Certificate of Satisfactory Completion

Onsite Sewage System Installation Notice of Inspection

Final Inspection Request and Notice - Onsite ID: 412384

Construction-Installation Permit

SECTION 3 - As Built Plan

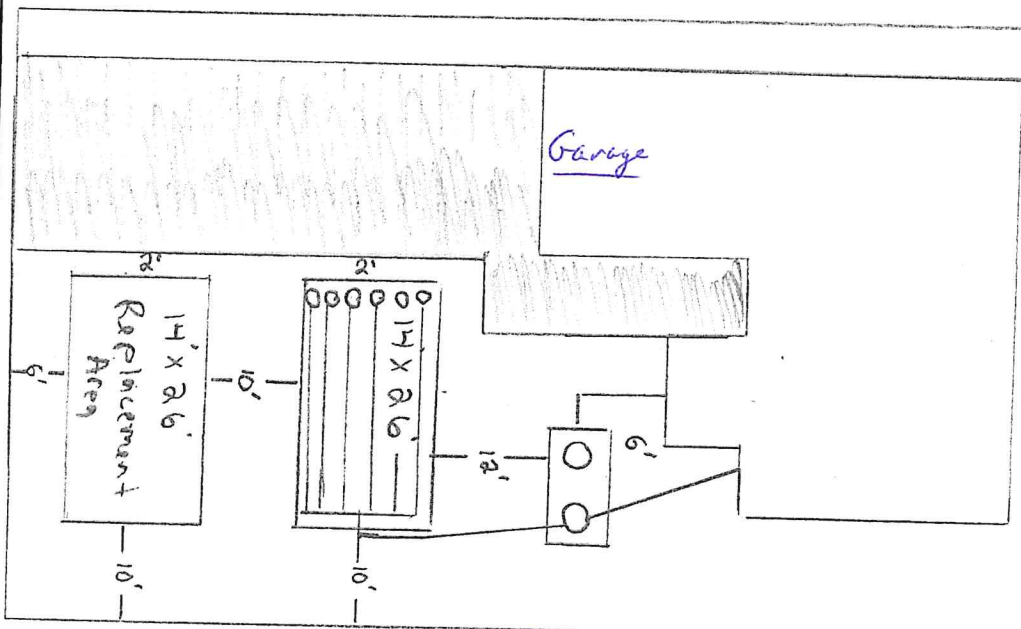
An inspection of this onsite sewage disposal system has identified the following:

14' x 26 ft = 364 sq. Ft. OK

10' Setback to garage - OK.

12 Orifices * 6 laterals = 72 orifices - OK.

Sand Filter - be sure there is 3" of rock below
all laterals. Add rock to cover orifice shields,
install fabric, and 6 to 12 inches of sand
crown.

Pump and alarm OK - 72 "sq. ft.
Submit new Final Insp. Request.

* Submit revised hydraulic calculations
and manifold/lateral design with
Orifice spacing. (Rec'd 9/25/13)

Revised Site Plan

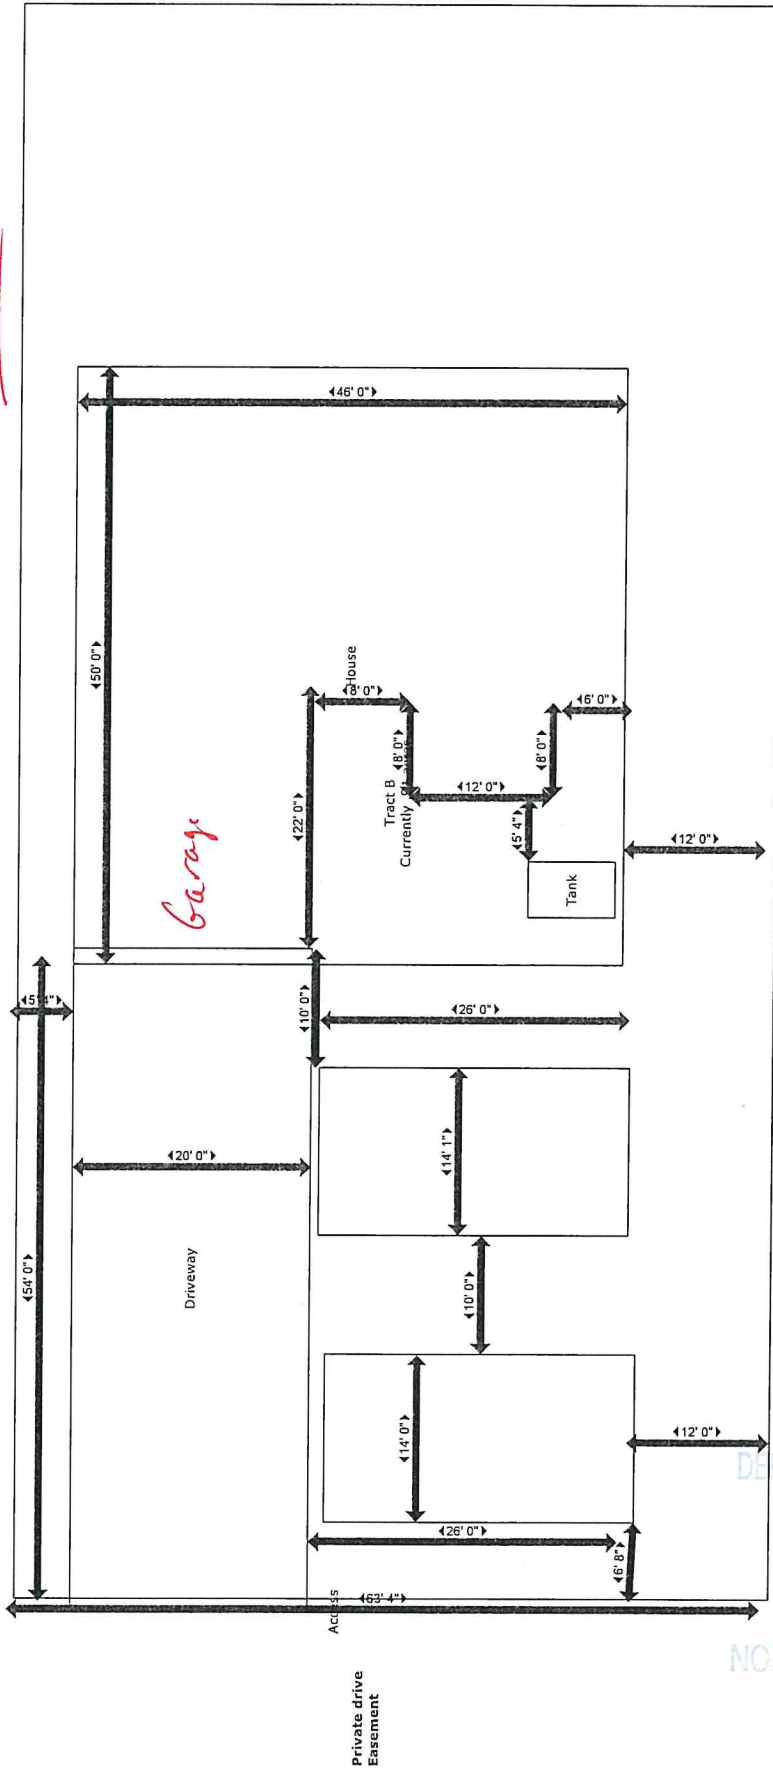
Revised Layout
(Constructed in this location)
B5Duff

APPROVED

14x 26' SAND FILTER MANIFOLD-BOTTOMLESS DISCHARGE

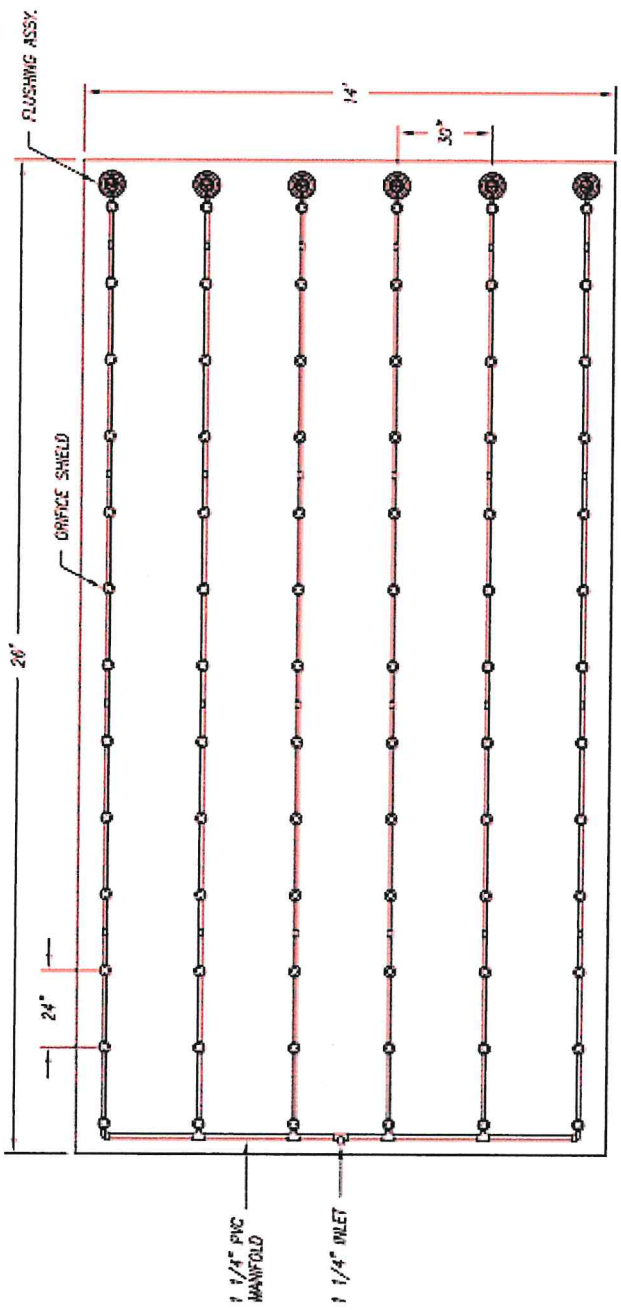
OS 4/2384
OK-BSD/wh

72" Squirt

Revised Plans
APPROVED
9/25/13

Proposed
Water line
Location

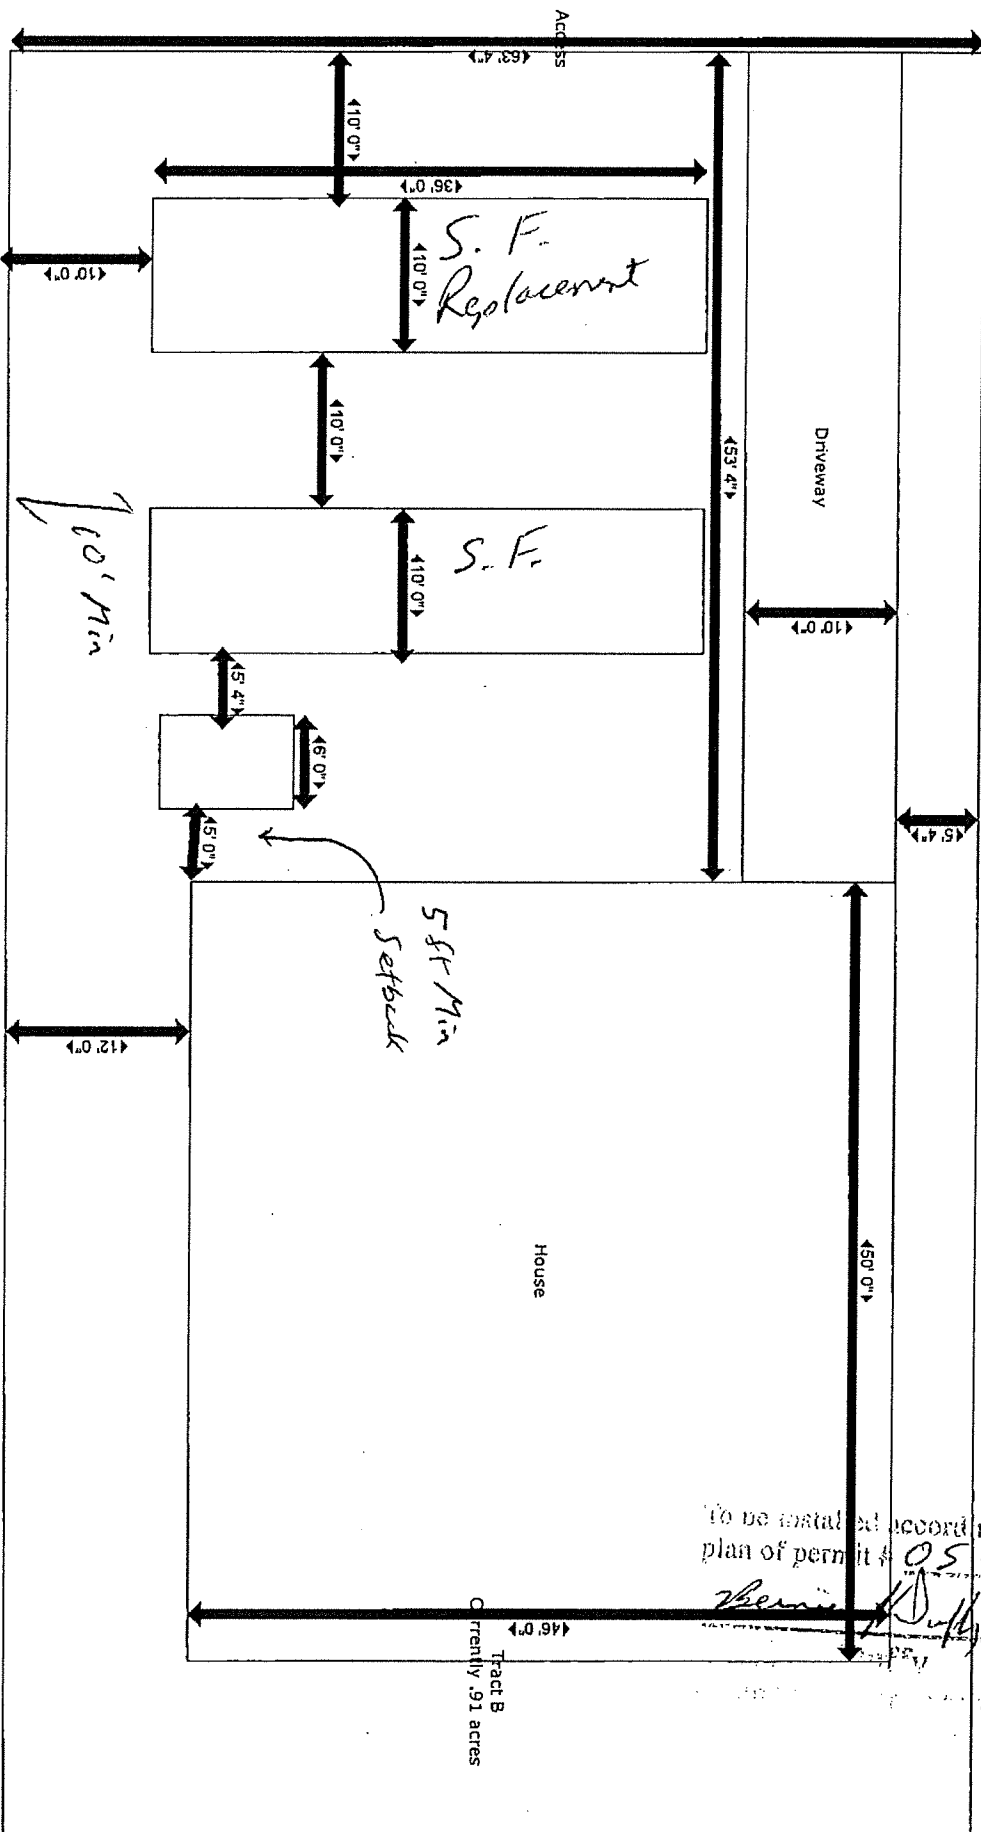
10 FT setback required to
all septic components

Also please show the location of the proposed water line. Minimum 10 ft setback to any portion of the septic system.

SF Cross-section

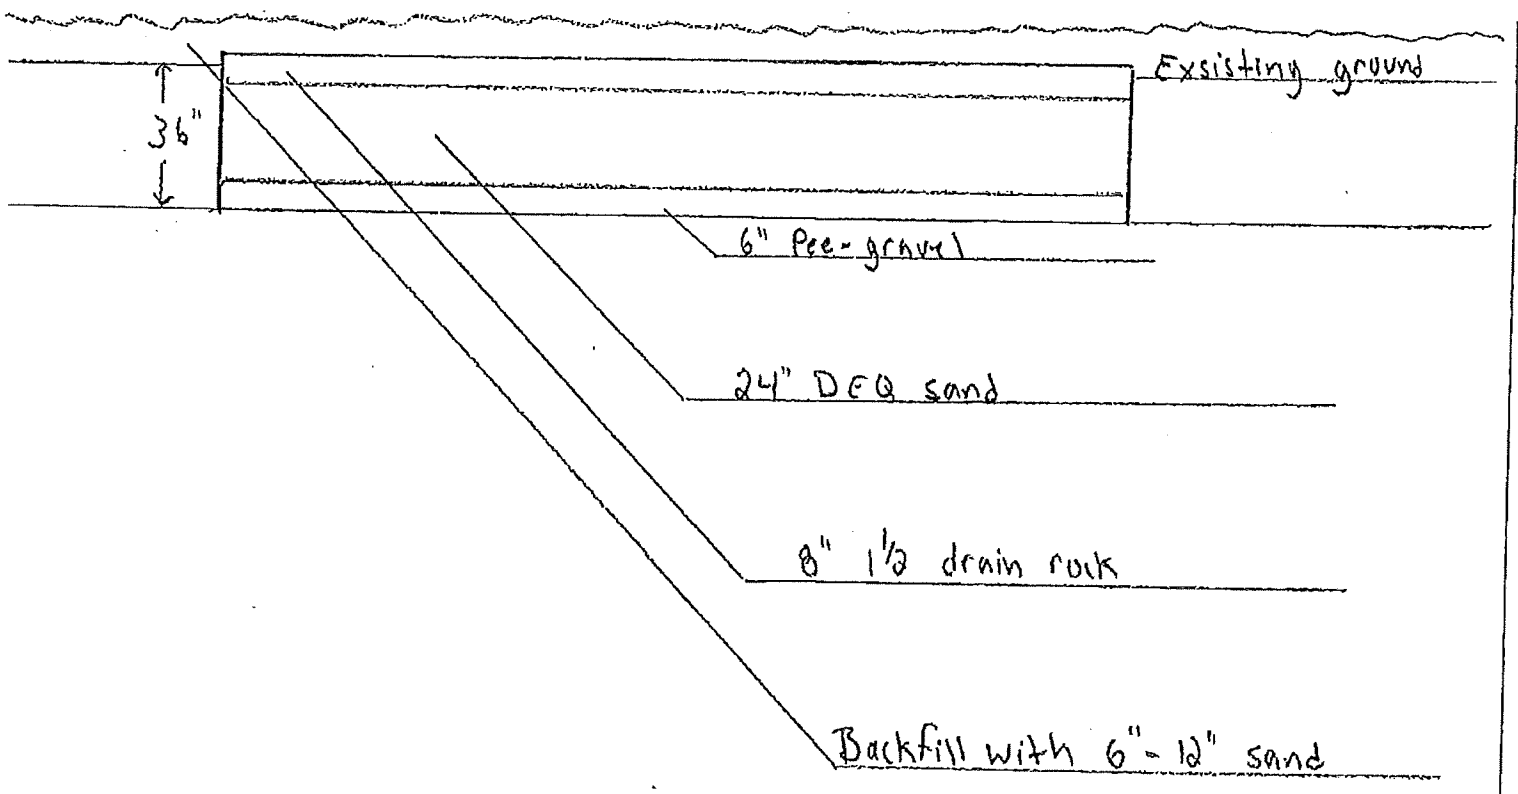
3. Sand filter plans shall include a sand filter cross section. The detail shall indicate the materials proposed, thickness of layers, crown, soil backfill (if needed due to depth), and other information for construction of the sand filter.

Pump Selection for a Pressurized System

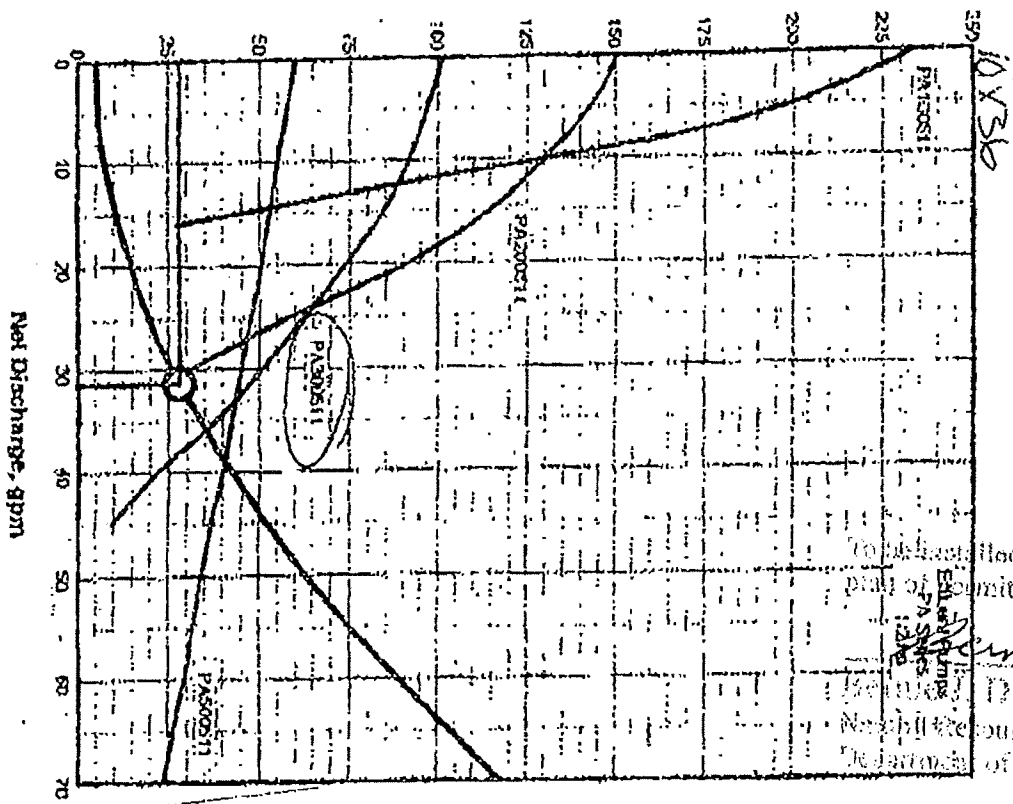
4. The sand filter plans shall include the manifold layout indicating pipe sizing, orifice spacing, lateral spacing and dimensions.
5. Pump information, sizing and hydraulic calculations shall be submitted.
